**ZONING AMENDMENT  
& SUBDIVISION STAFF REPORT****Date: March 6, 2014****APPLICANT NAME**

Joe Mason Subdivision

**LOCATION**1412 & 1416 Wolf Ridge Road  
(East side of Wolf Ridge Road, 200'± North of Moffett Road)**CITY COUNCIL  
DISTRICT**

Subdivision approval to create 1 lot, and Zoning approval to rezone the site from B-3, Community Business District, to B-3, Community Business District, to amend a condition of approval.

# SITE PLAN

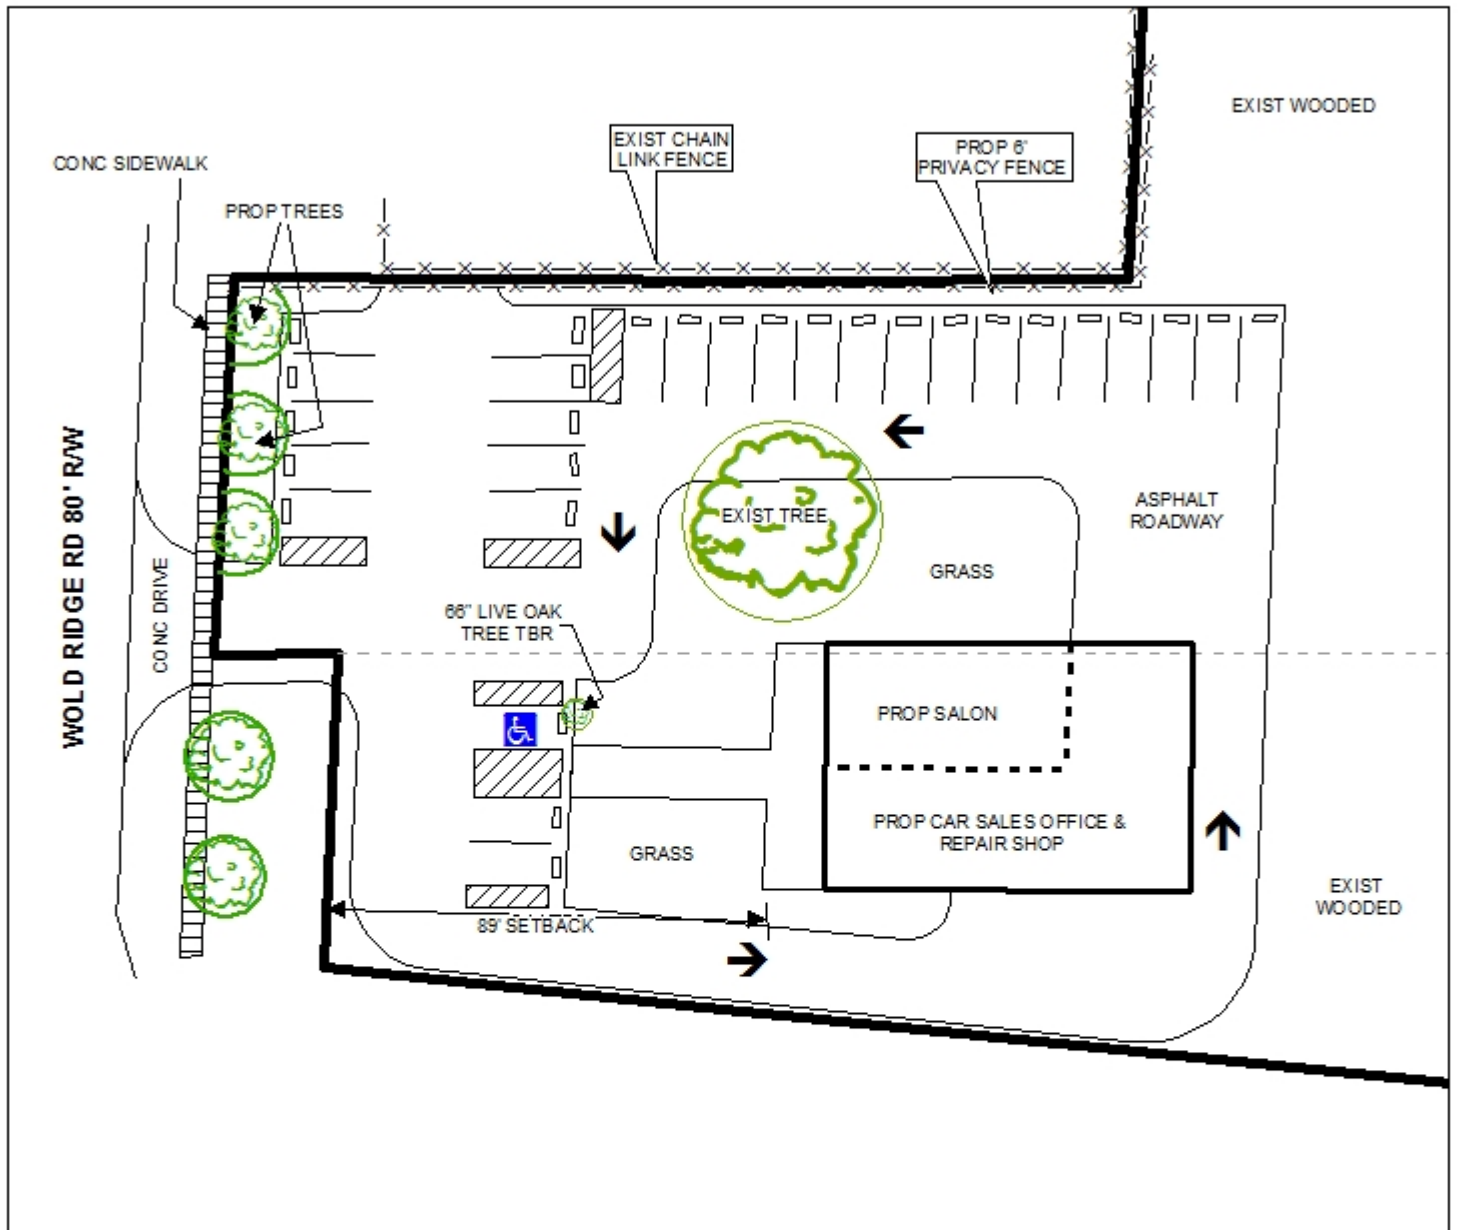
Zoning approval is not site plan specific, but a site plan is required as part of the application to the Planning Commission. The site plan submitted shows the elimination of the 66 inch live oak tree to make way for parking. It appears that the site plan could be revised to save both the 66 inch live oak and the 60 inch live oak, and still provide adequate parking and circulation, as only approximately 31,000  $\pm$  square feet of the 87,000  $\pm$  square foot site is proposed for development. Live oaks are a signature tree for Mobile, thus their protection is encouraged via regulation.

The 25-foot minimum building setback line, required in Section V.D.9., is not illustrated and labeled on the preliminary plat. If approved, the 25-foot building setback line should be illustrated and labeled on the Final Plat from the new property line after dedication along Wolf Ridge Road, and for the Pringle Drive frontage.
